CONSENT & MINOR VARIANCE APPLICATION City of Ottawa | Ville d'Otta COMMENTS TO THE COMMITTEE OF ADJUSTMENT PANEL 2

Site Address: 75 Aylen Avenue

File No.: D08-01-25/B-00061 & D08-01-25/B-00062

Report Date: May 01, 2025 Hearing Date: May 06, 2025

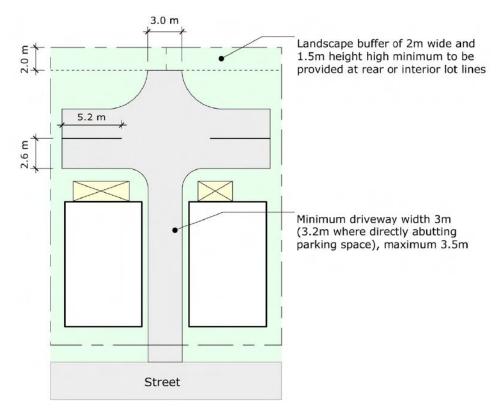
The six proposed parking spaces in the rear yard do not appear to be functional. Provide swept path analysis (AutoTURN) to demonstrate that cars can maneuver in and out of the spaces. Recommend removing two of the six spaces and providing a "hammerhead" turning space as demonstrated in the new Zoning By-Law, see below:
